IREDELL COUNTY HEALTH DEPARTMENT

IMPROVEMENT PERMIT / AUTHORIZATION TO CONSTRUCT / OPERATION PERMIT / EXISTING SYSTEM INSPECTION

PERMIT# 147671 PIN# 4730461196 2872 LEE CHRISTIE DATE 2/21/08

SUBDIVISION TWIN CREEKS BLOCK / SECTION 2 LOT 59/59A LOT AREA 1.05 + OFFSITE SITE CLASS. PS DESIGN FLOW 480 L.T.A.R. .3

INITIAL SITE SKETCH

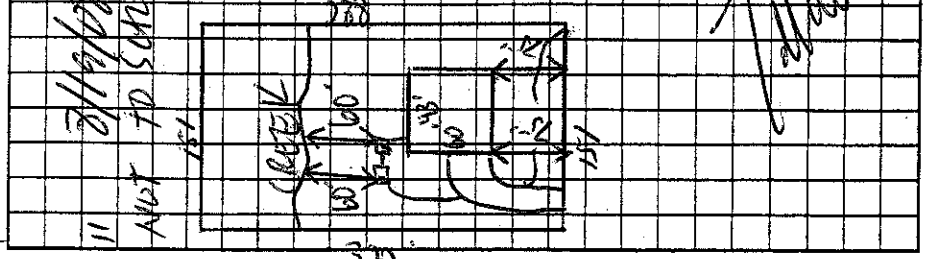
"POLYWORK" "FILTER" CAP Approved By Rollins Soil & Environmental

AS BUILT SKETCH

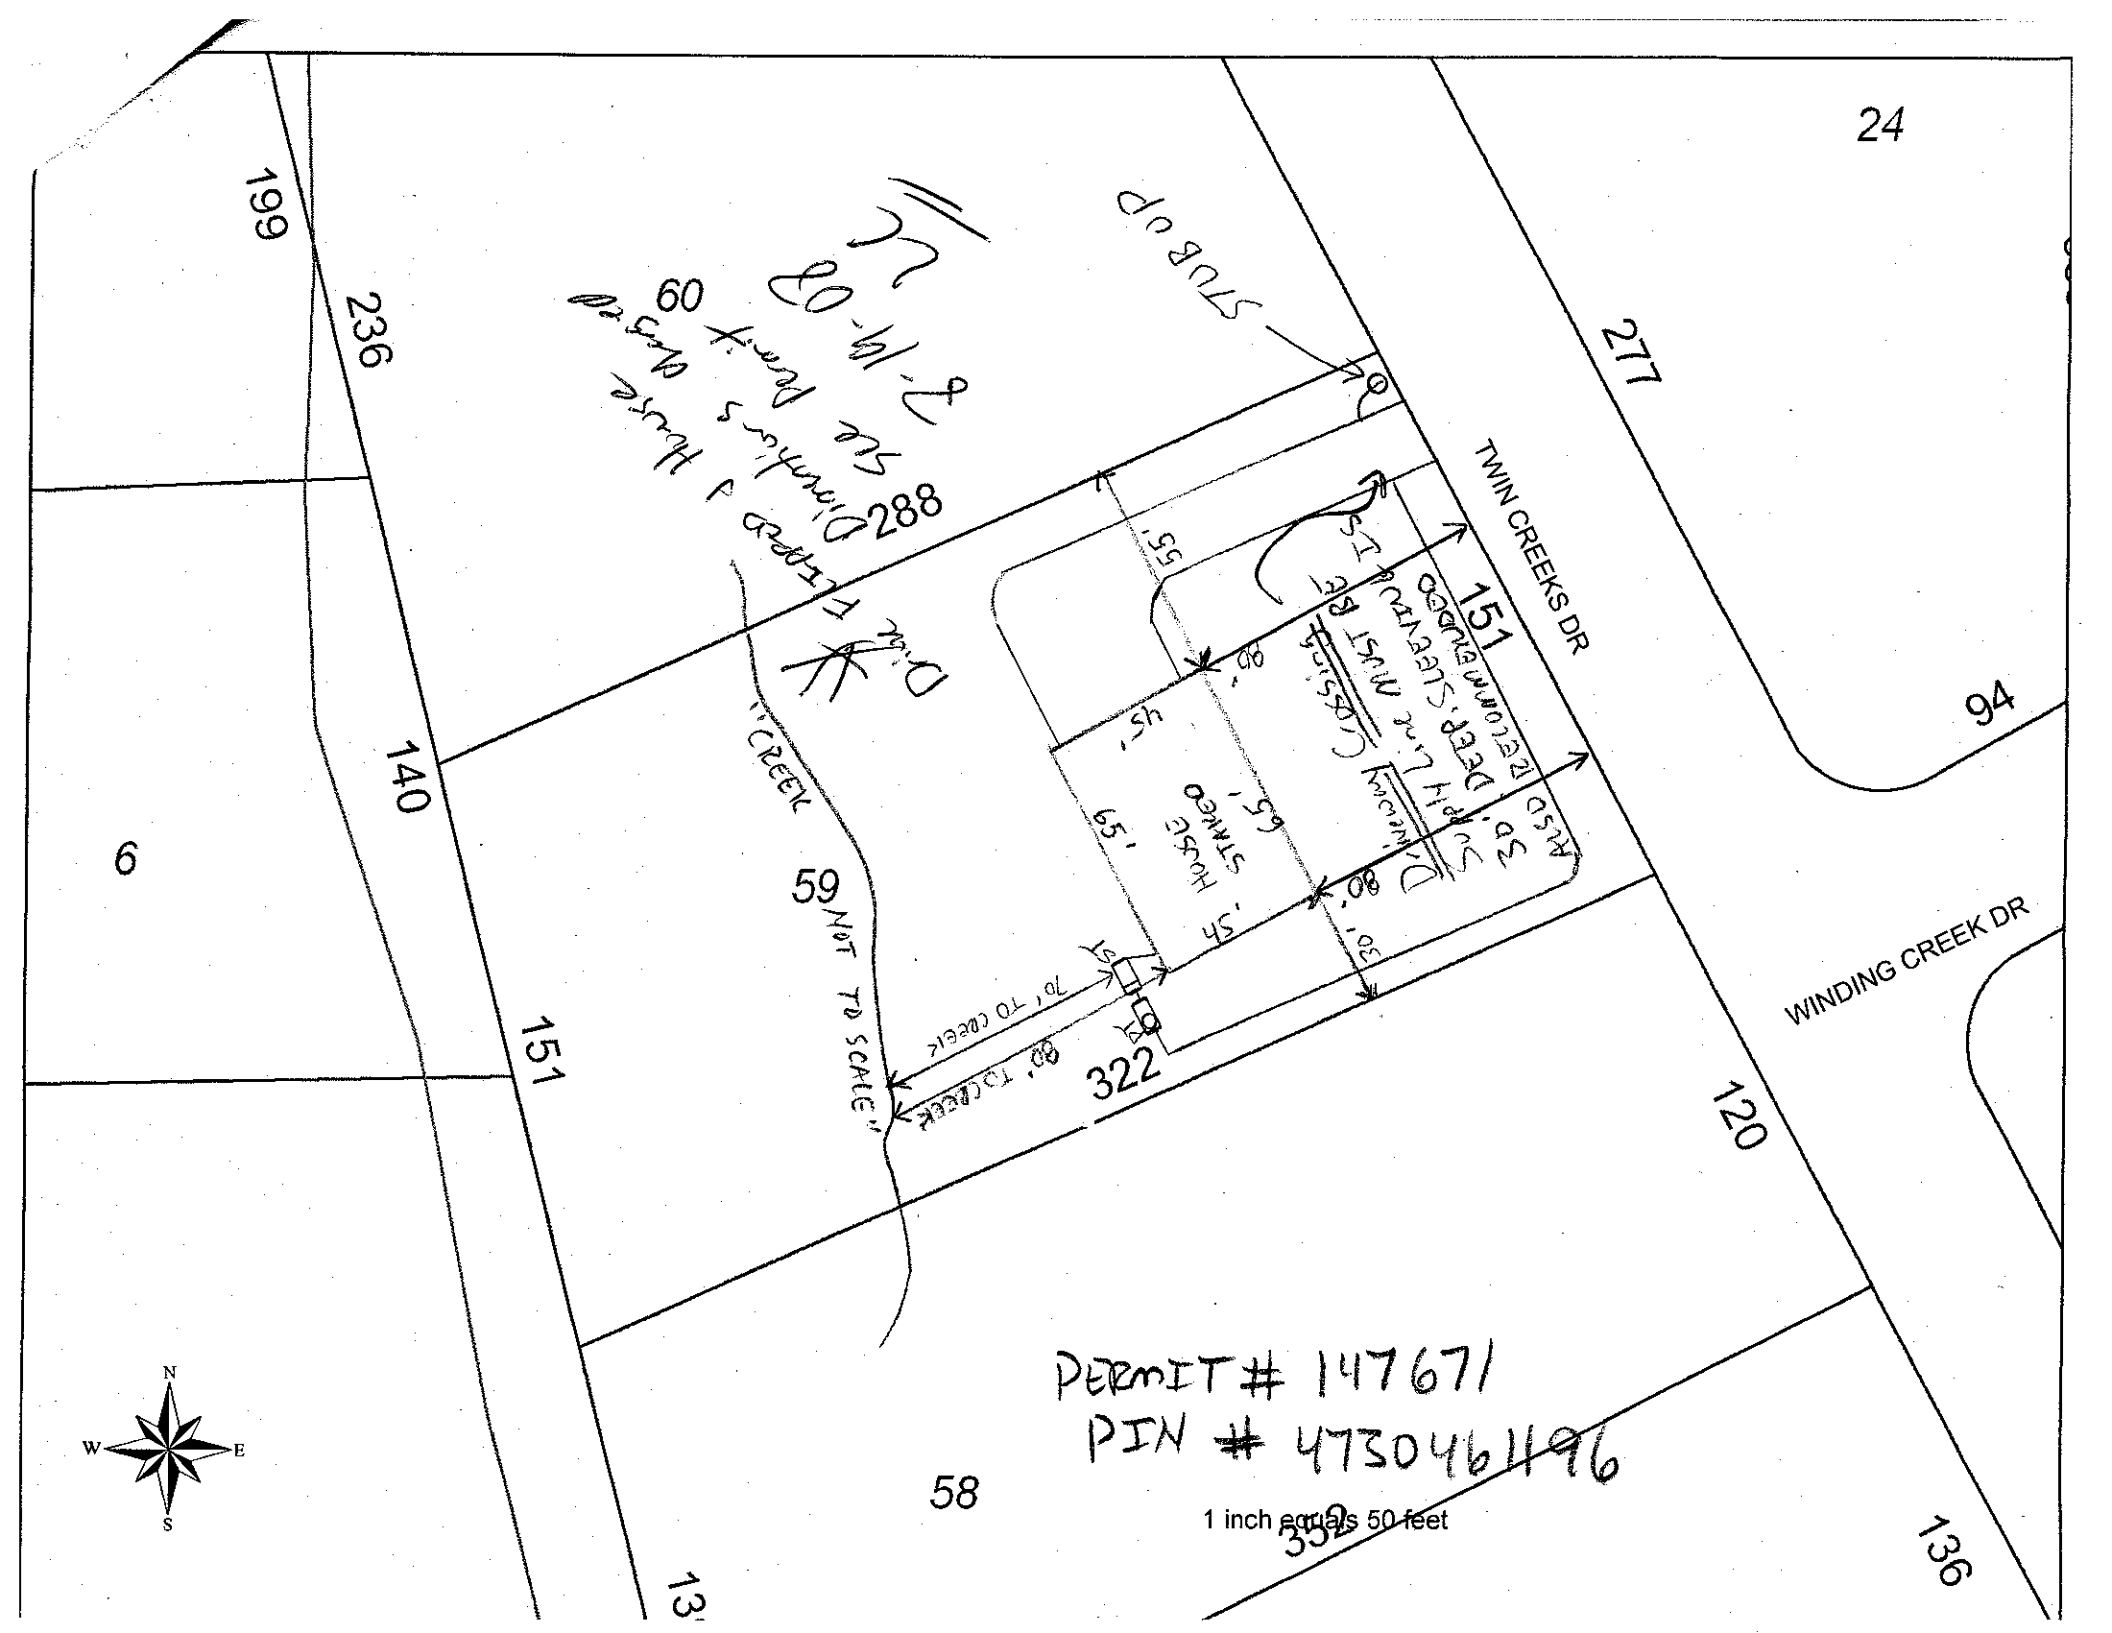
A/C comments

(1) House is a 60' deep by 43' wide plan & 60' is 15' longer than Approved. Builder will need House 75' off Front P/L & extend extra 10' of Home toward Back. This will make the tanks 60' From the creek. Builder Acknowledges Spide limitations & will double check setbacks especially the tanks being 50' to Creek. Driveway has flipped & supply will be installed under driveway per State Rules.
